## Artesian 230kV Substation Expansion Project CPUC Minor Project Refinement Form

Report No.: MPR-7

Z133523 – Location 45 (E21), first pole west of Camino San Bernardo, between Coastwood Rd. and Thornmint Rd. at approximately 33.0188903, -117.1024021.

Photo 1. Overview of access road and Location 45 (E21). View northeast.

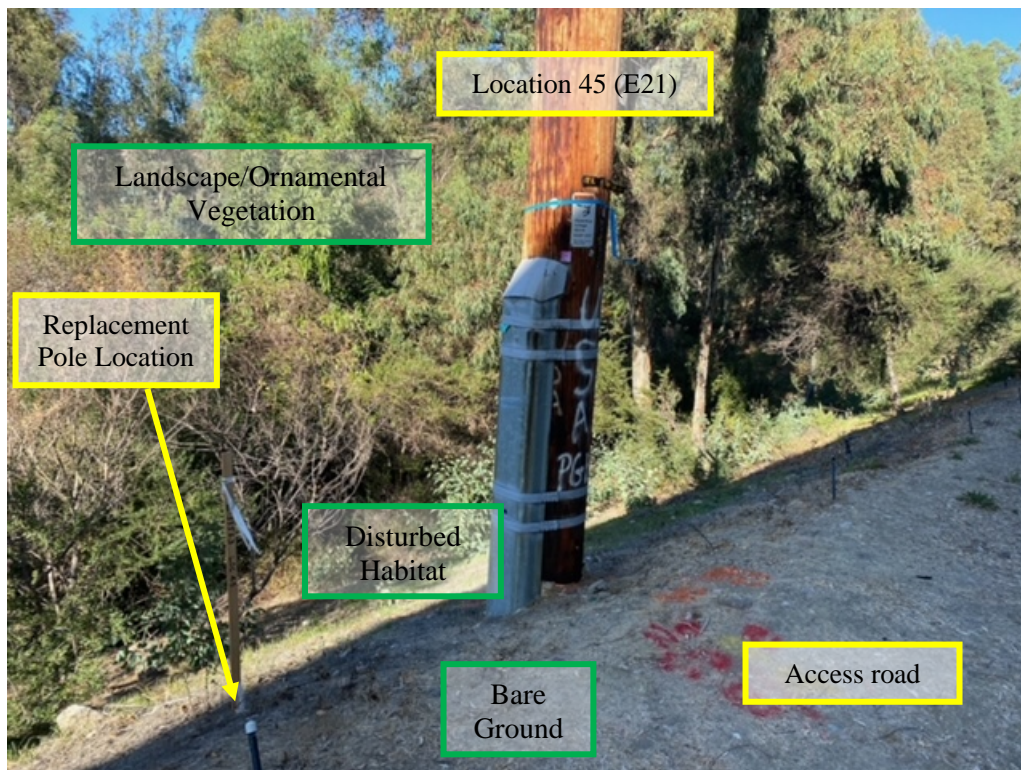
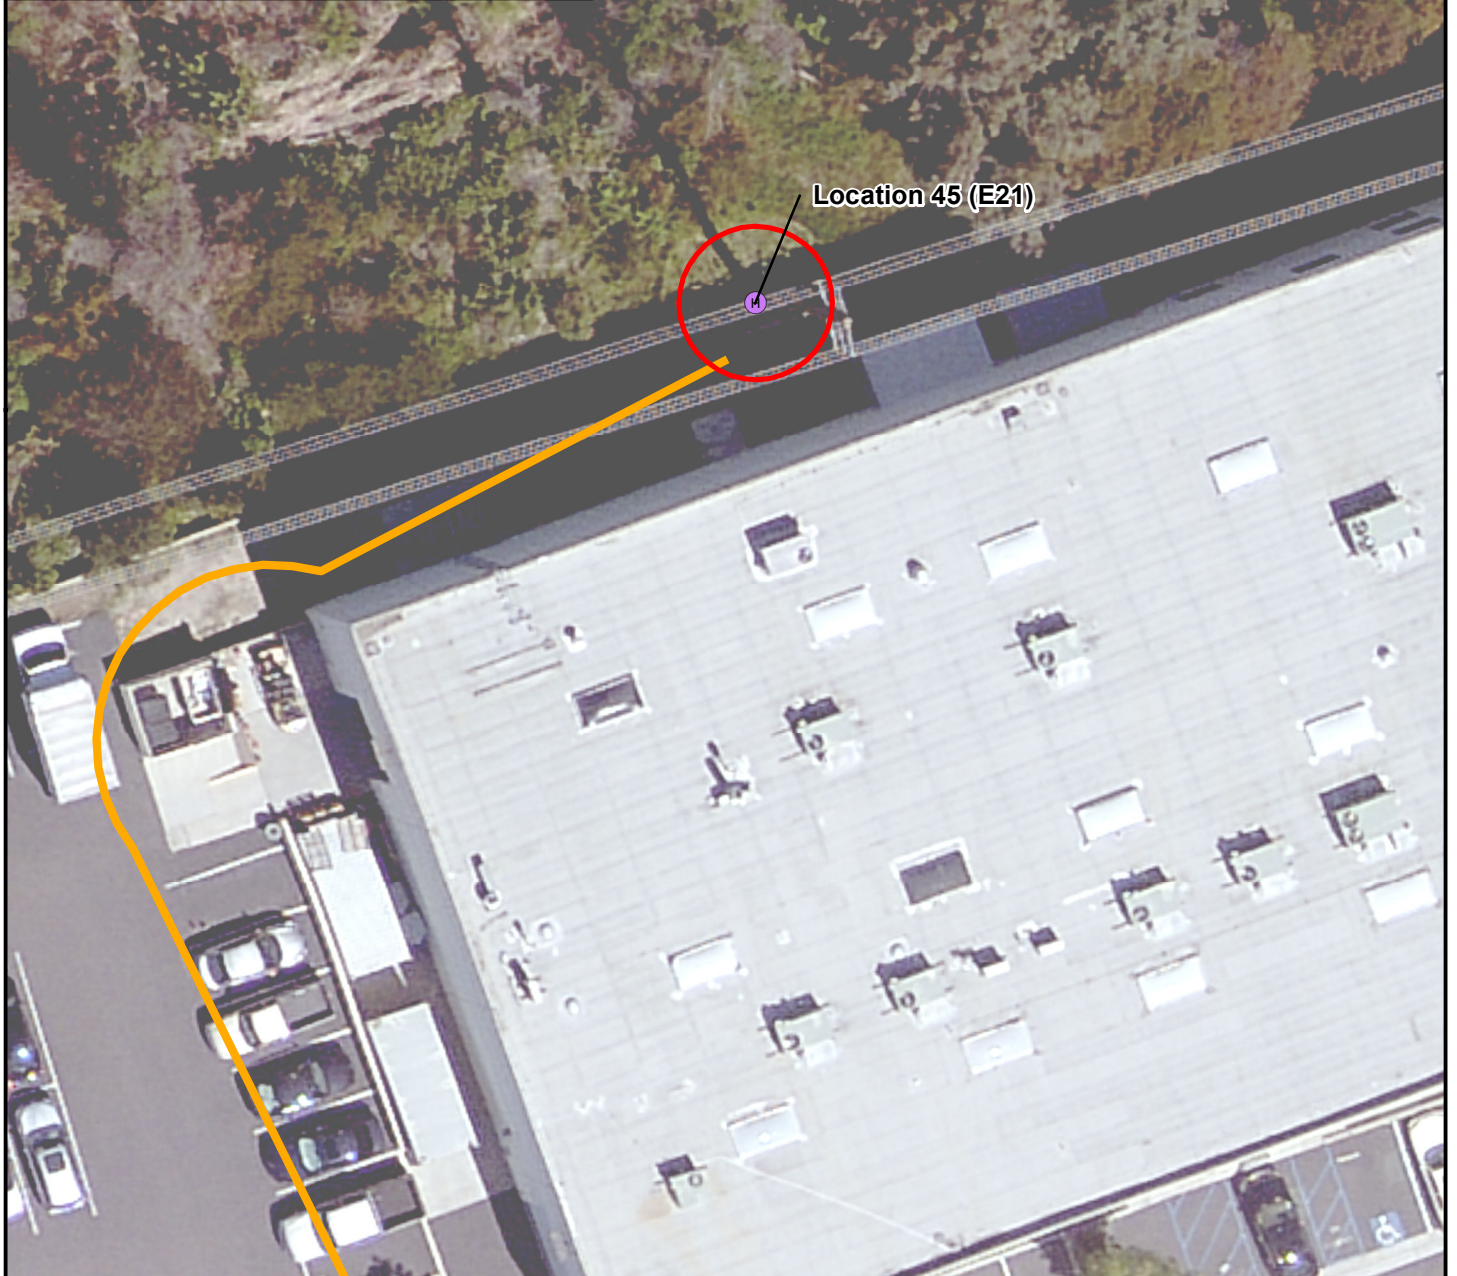
The requested change is for the proposed work activities at Location 45 (E21). The current project includes overhead work only on this pole. The proposed change includes replacing the existing wooden pole with a steel-weathered pole (See photos in Attachment A).

The original work activities at Location 45 (E21) included overhead work only, consisting of a 314 sq. ft. work area around the pole, plus access via an existing dirt road. Final design of the project identified the need for replacement of this pole, consisting of the same work area size and access, and following methodology similar to other wood pole replacements that are already included in the project description.

CPUC requests biological monitor conduct a site visit.
